ADDENDUM NO. [3] Date: March 29, 2018

RE: WESTERN TECHNICAL COLLEGE

ARC LIBRARY REMODELING & VETERAN'S CENTER ADDITION

400 SEVENTH STREET NORTH LA CROSSE, WISCONSIN 54601 HSR PROJECT NO. 17026

M100R

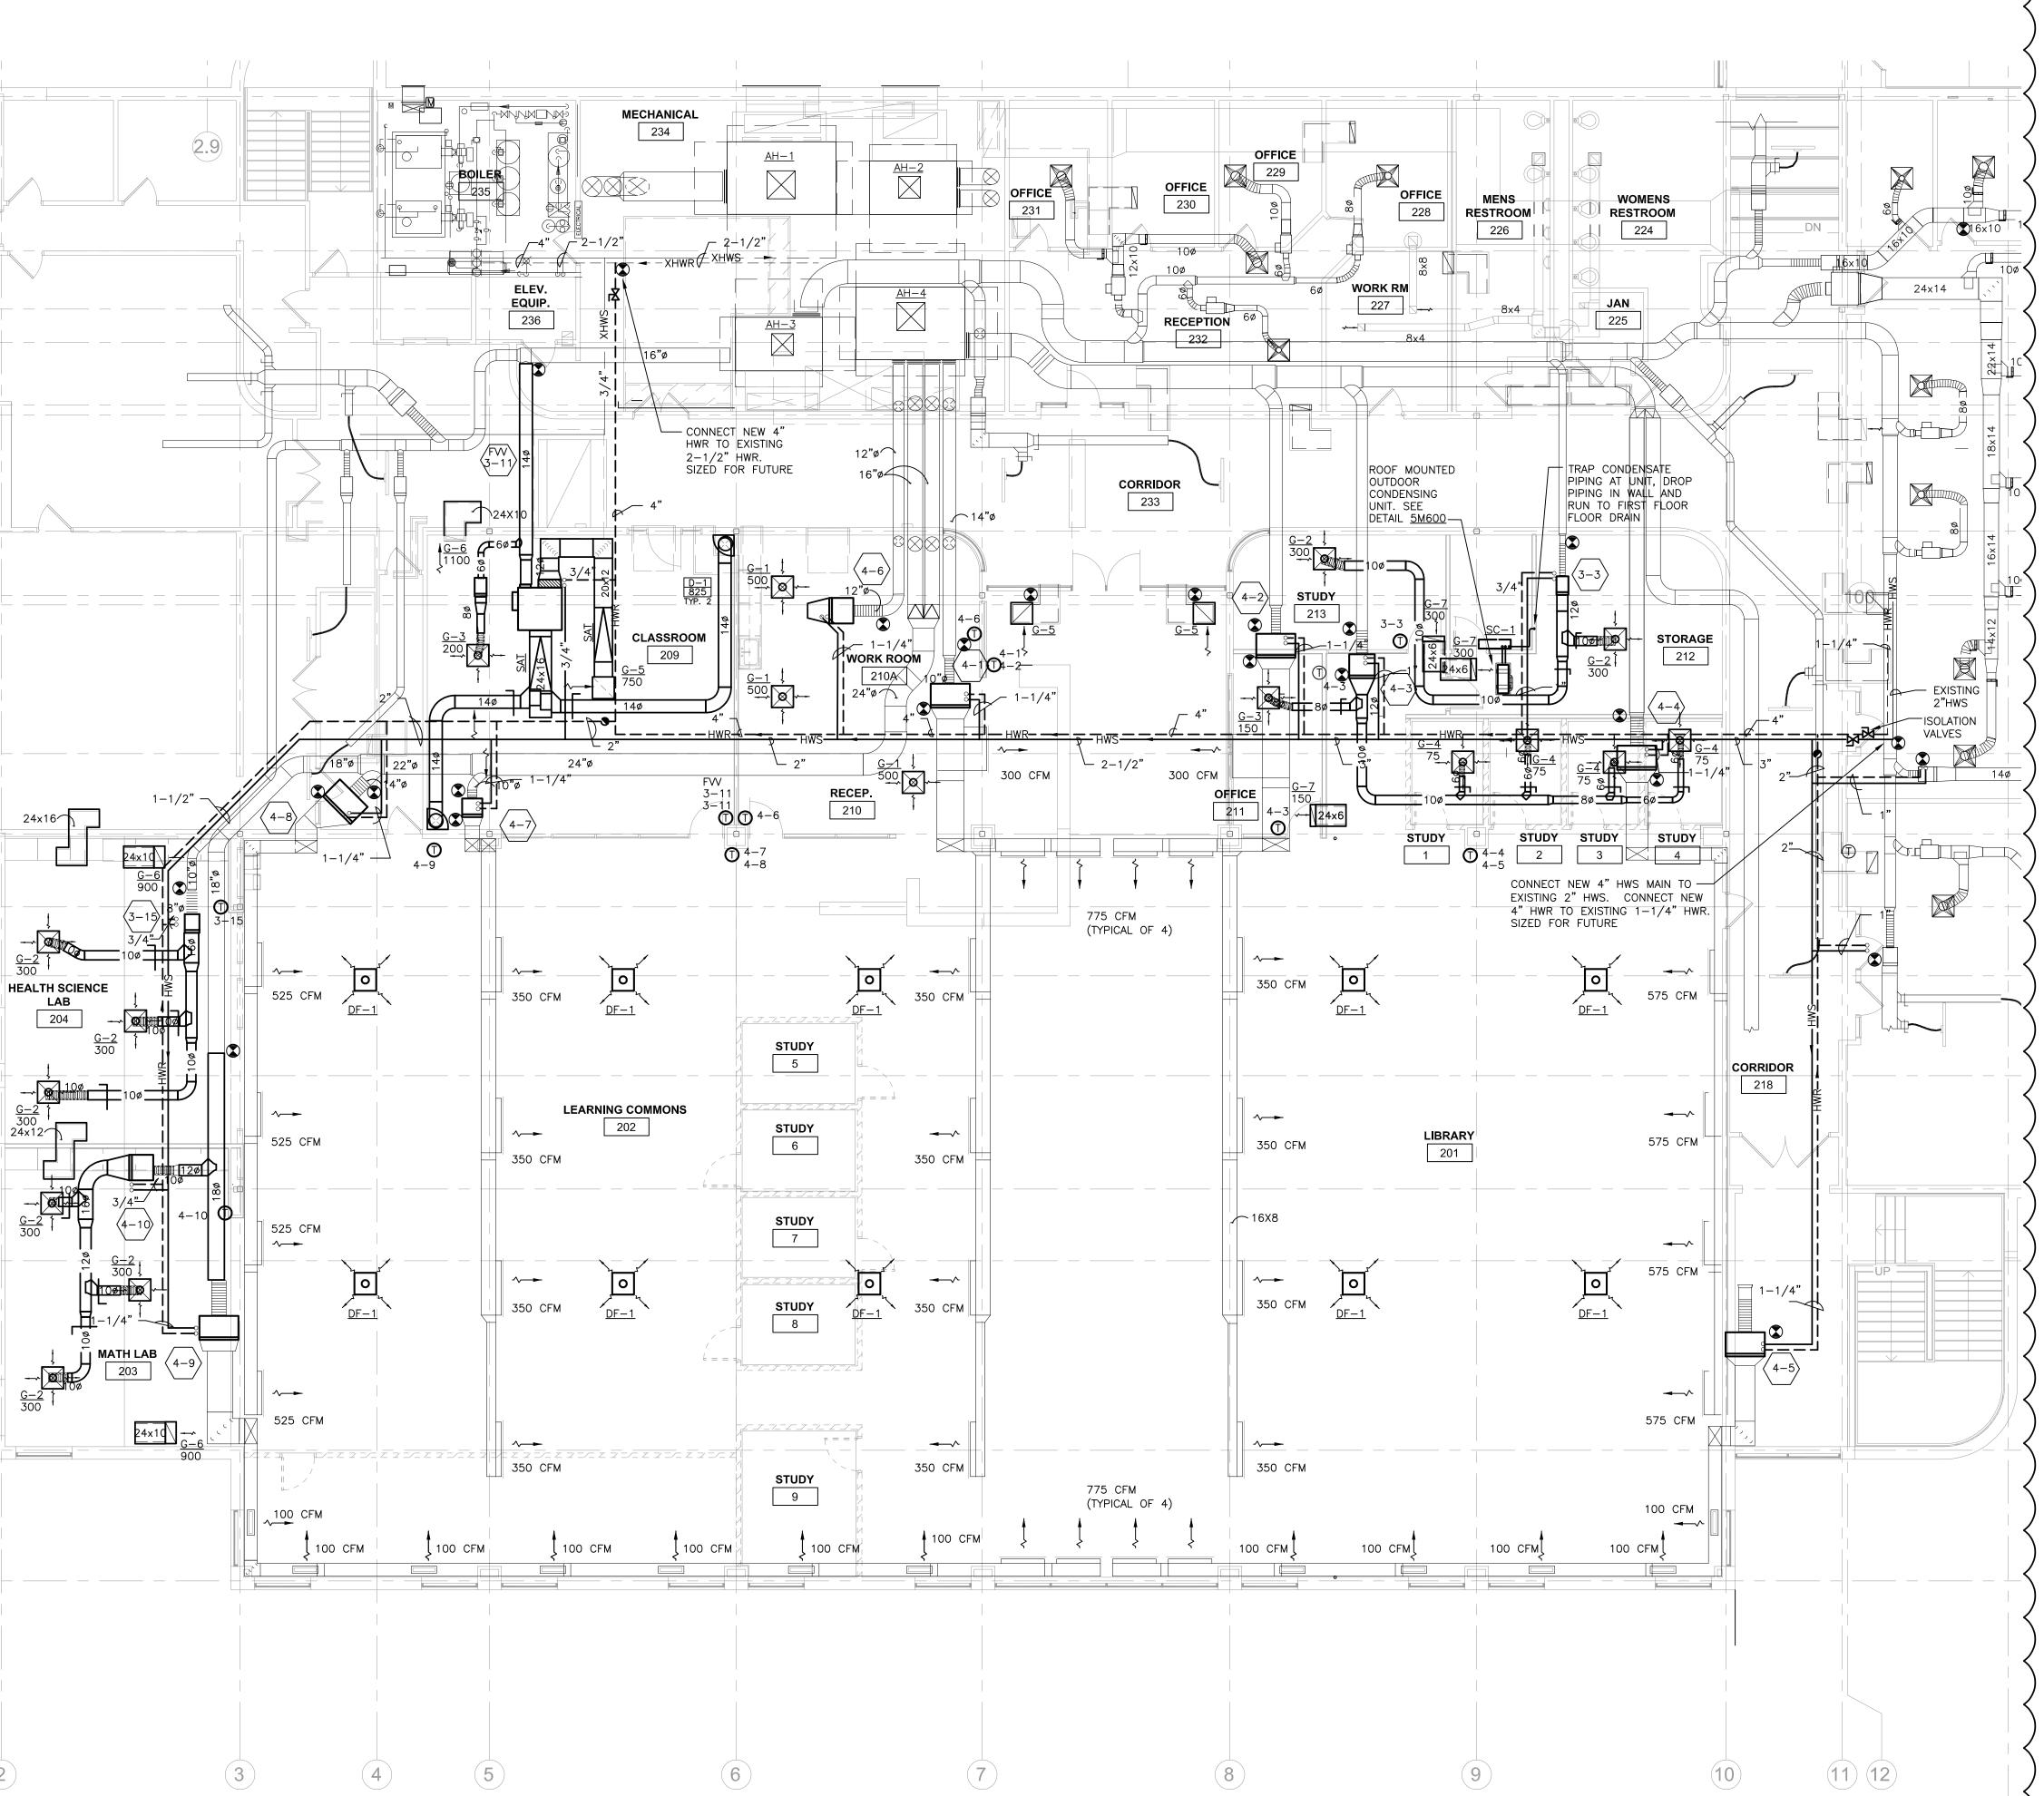
- 1. Sheet M100R HVAC REMODEL PLAN 30 x 42 attached hereto
  - a. Revisions clouded on Drawing.
- 2. Sheet M600R HVAC SCHEDULES AND DETAILS 30 x 42 attached hereto

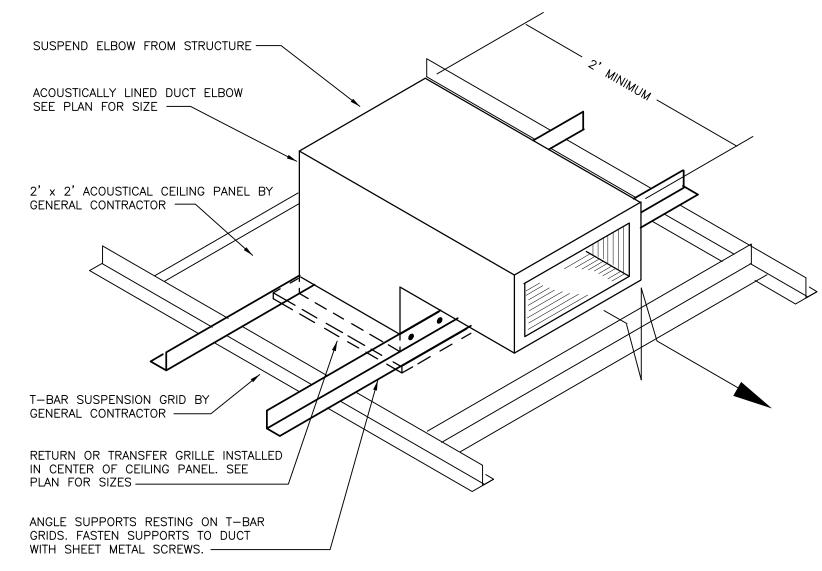
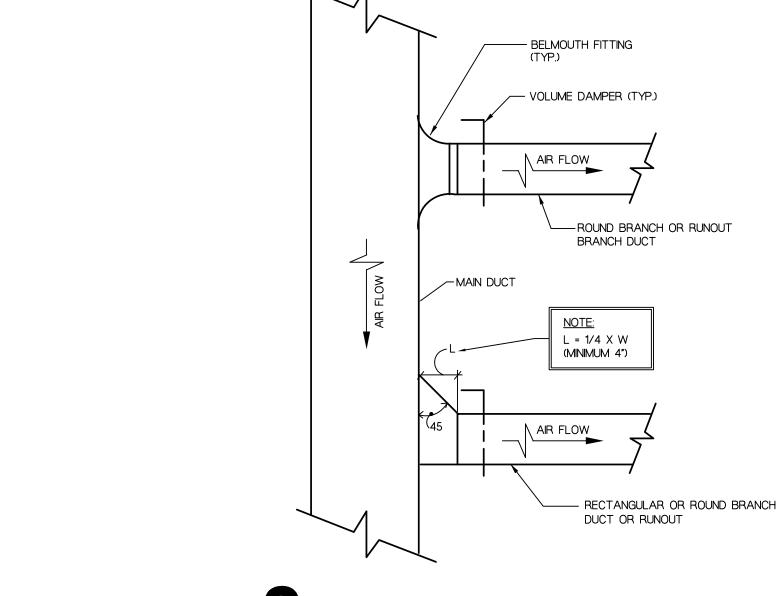
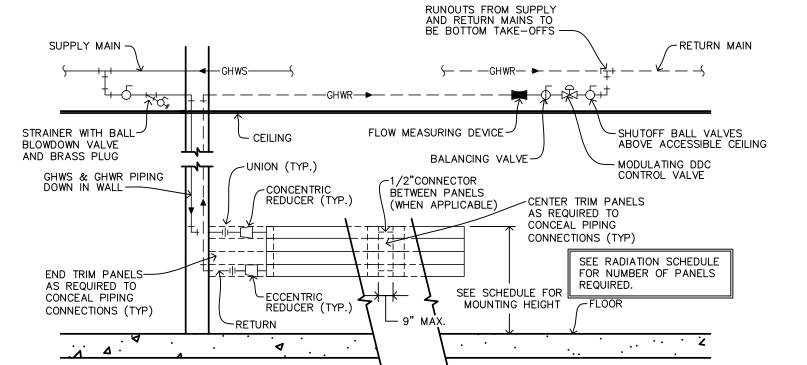
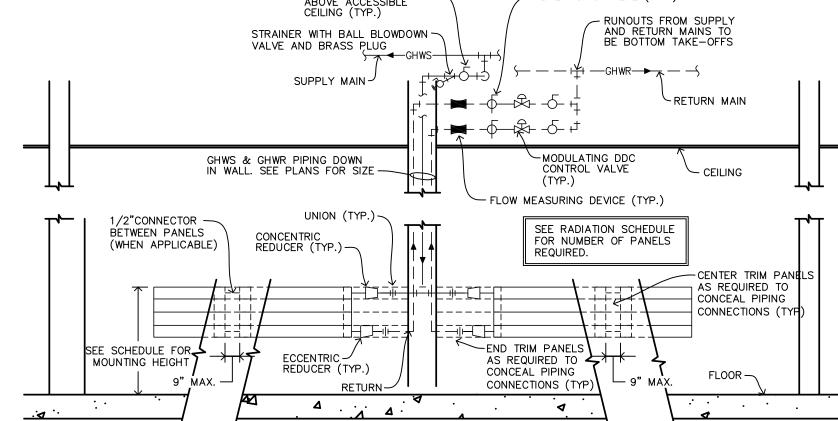
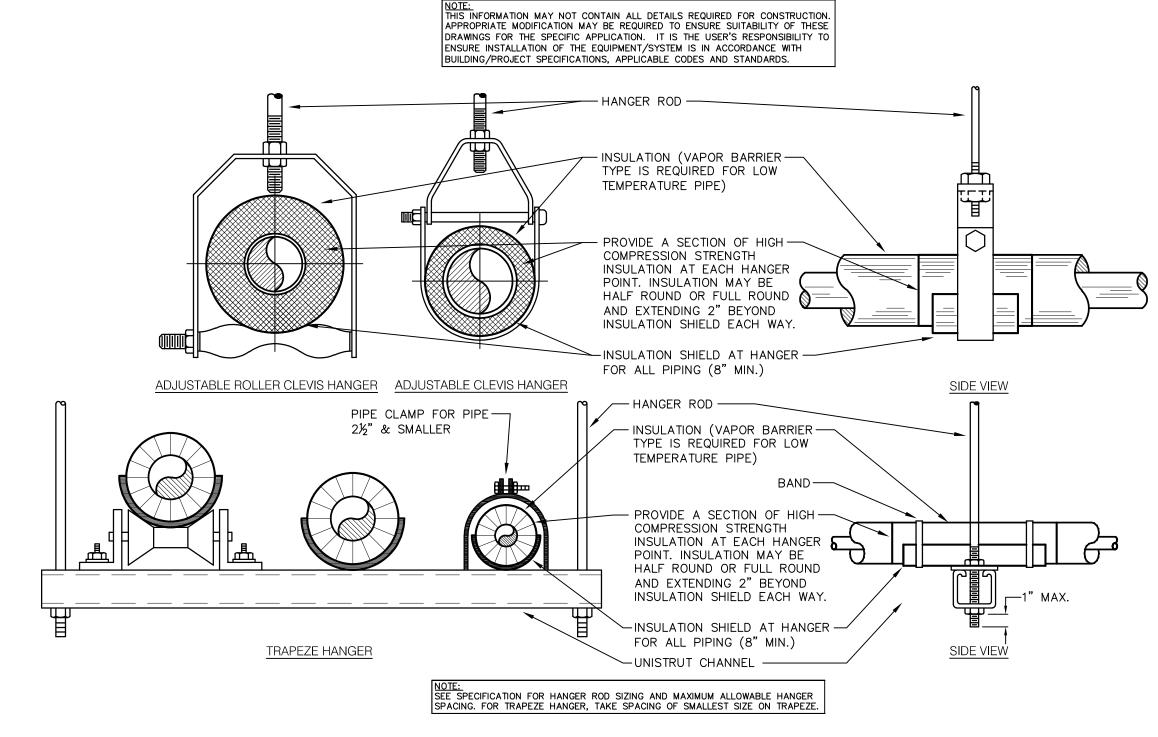
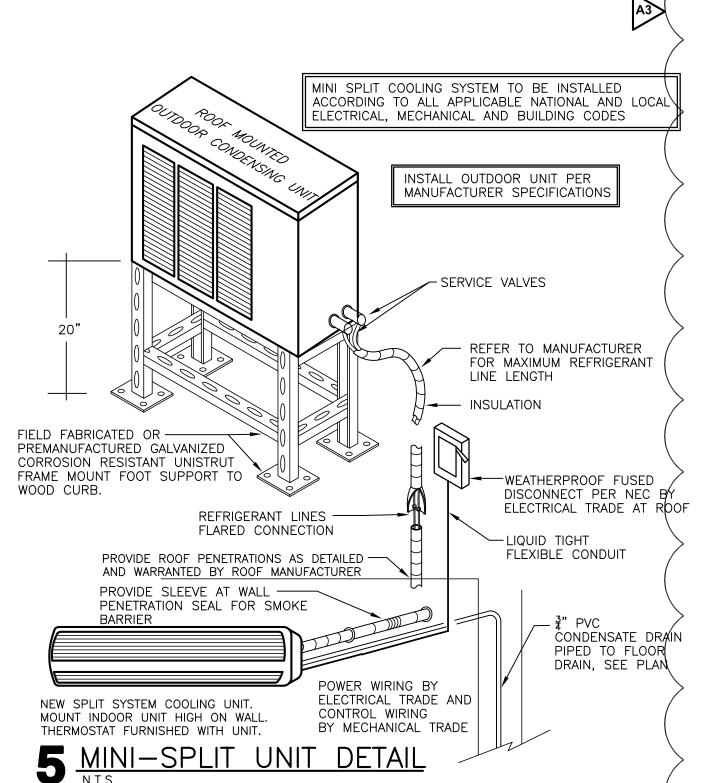
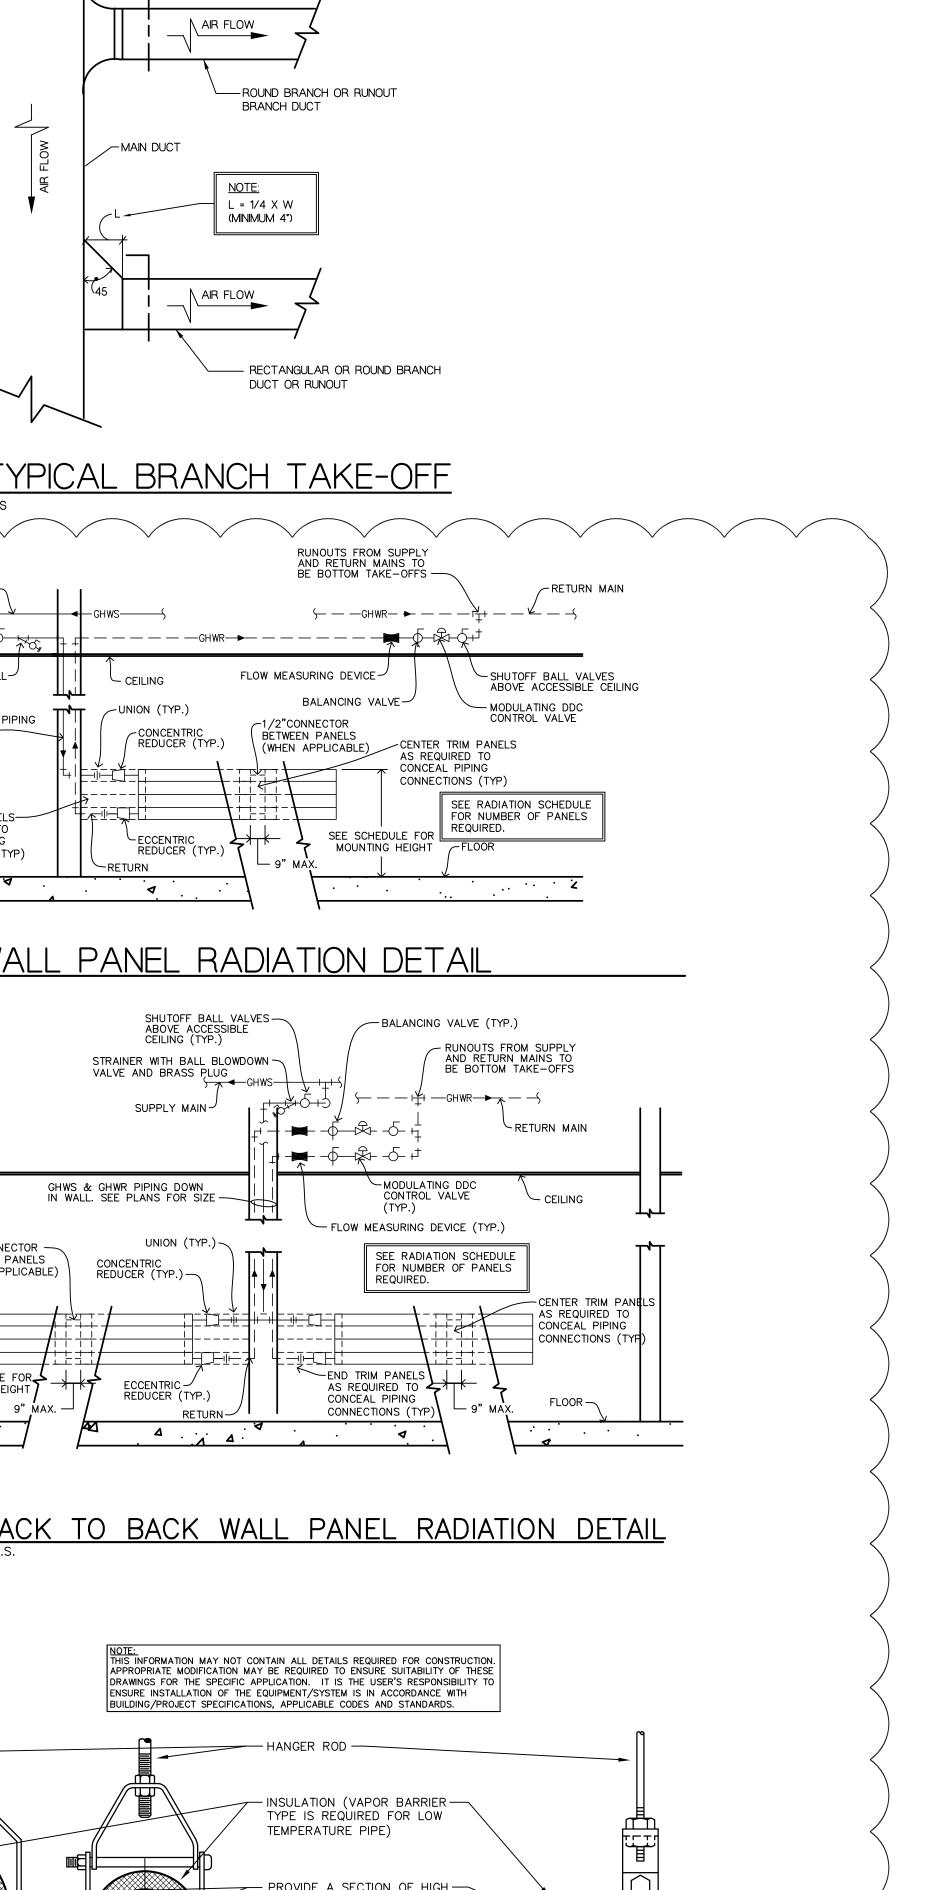
- a. Revisions clouded on Drawing.
- 3. Sheet E102R PARTIAL SECOND FLOOR LIGHTING PLAN 30 x 42 attached hereto
  - a. In classroom #209, provide a Wattstopper, model # LMIO-101 digital input/output interface relay. This relay will be used by the Temperature Control Contractor to control HVAC fan powered FVAV 4-6 Box. Refer to clouded change.
